# Particle Measurement Programme

## **Non-Exhaust Emissions Draft GTR Feedback Part 1**

*Theo Grigoratos and  
Barouch Giechaskiel*

*22 SEP 2022*

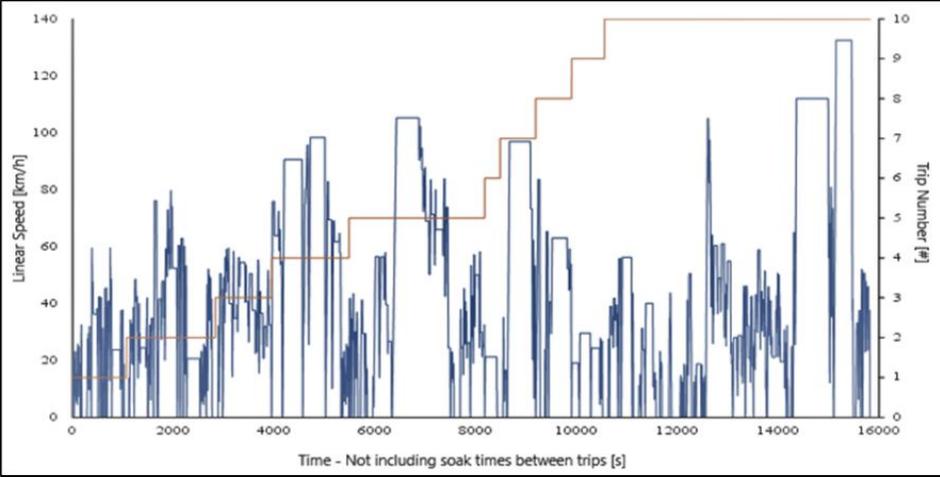
Excerpt from	Current text	Discussion Item – Proposed changes
3.	7.4.2 Brake enclosure design – Design specifications (l) and (m)	<p>Current text:</p> <p>(l) Apply Computational Fluid Dynamics (CFD) to calculate the airspeed values at the nine positions of plane C. Carry out the computation at three different cooling airflow settings representing the minimum, 50 per cent, and the maximum of the operational airflow range of the test system. The simulation time shall be of sufficient duration to detect any instability in the airspeed pattern that may affect the airspeed values. Conduct the simulation without a brake assembly or a brake fixture installed. Airspeed at each position shall not vary by more than <math>\pm 20</math> per cent of the arithmetic mean of all measurements for a given flow;</p> <p>(m) It is strongly recommended that the testing facilities conduct physical measurements instead of the CFD simulations to verify the uniformity of the airspeed using the nine positions defined in points (k) and (l) of this paragraph;</p>	<p>It has been proposed by several stakeholders to mandate the experimental validation of the speed uniformity check and make the CFD optional. The proposed text would be:</p> <p>(l) Measure the airspeed values at the nine positions of plane C. Carry out the measurement at three different cooling airflow settings representing the minimum, 50 per cent, and the maximum of the operational airflow range of the test system. Conduct the measurement without a brake assembly or a brake fixture installed. Airspeed at each position shall not vary by more than <math>\pm 35</math> per cent of the arithmetic mean of all measurements for a given flow;</p> <p><del>(m) It is recommended that the testing facilities conduct also CFD simulations to verify the uniformity of the airspeed using the nine positions defined in points (k) and (l) of this paragraph. In this case, the simulation time shall be of sufficient duration to detect any instability in the airspeed pattern that may affect the airspeed values;</del></p> <p>JRC's suggestion: We agree in mandating the experimental validation of the speed uniformity. We think that the allowed flexibility shall increase to <math>\pm 35</math> per cent of the arithmetic mean of all measurements for a given flow to account for the measurement uncertainty. We recommend completely omitting the CFD measurement in this context as it does not add any value.</p>
